HISTORIC AND DESIGN REVIEW COMMISSION

July 01, 2020

HDRC CASE NO: 2020-263
COMMON NAME: US 90 underpass near the intersection of Mission Rd and Steves Ave
ZONING: UZROW
CITY COUNCIL DIST.: 5
DISTRICT: Mission Historic District
APPLICANT: James Gray
OWNER: Sean Strong/CITY OF SAN ANTONIO
TYPE OF WORK: Public art installation, park improvements
APPLICATION RECEIVED: June 11, 2020
60-DAY REVIEW: Not applicable due to City Council Emergency Orders
CASE MANAGER: Rachel Rettaliata
REQUEST:

2 SECTION: LIMESTONE BENCH
SCALE: 1"= 1'-0"

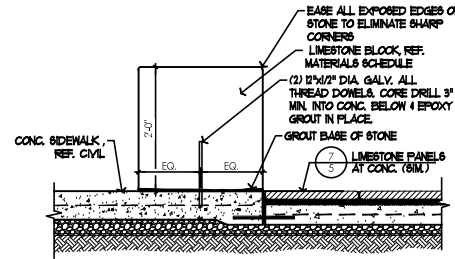
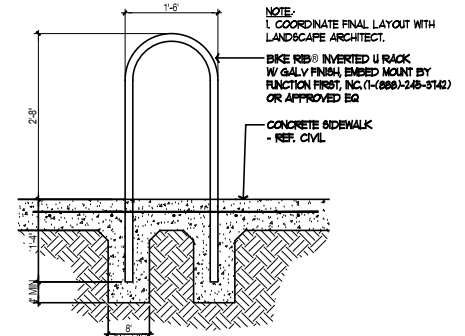
- d. PARK AMENITIES – The applicant has proposed to install a bike rack between existing columns in proximity to the public art installation. The bike rack proposed is a Bike Rib inverted u rack with galvalume finish. It will be installed in concrete. Additionally, the applicant has proposed to install limestone benches at the sidewalk. Staff finds the proposal consistent with the UDC.

6 DETAIL: LIMESTONE MISSION BLOCK
SCALE: 1"= 1'-0"

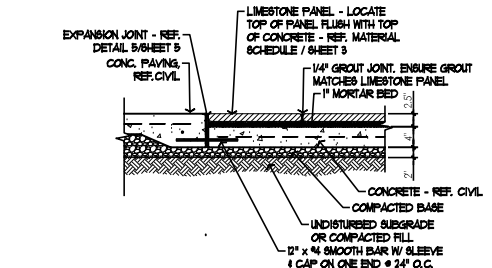
- b. PUBLIC ART – The applicant has proposed to install an art feature at the center island of the US 90 underpass which will include a representation of a map of the San Antonio Missions located on the San Antonio River. The map consisting of the river, roads, and annotations is planned to be engraved in 18-inch square limestone panels. The panels are to be arranged on the ground to make a complete map on the river and roads near the San Antonio Missions. Limestone blocks representing the San Antonio Missions are planned to be placed on the map in the general locations of the Missions. Engravings of the respective Mission will be installed as limestone caps on top of each block. Staff finds the proposal appropriate.
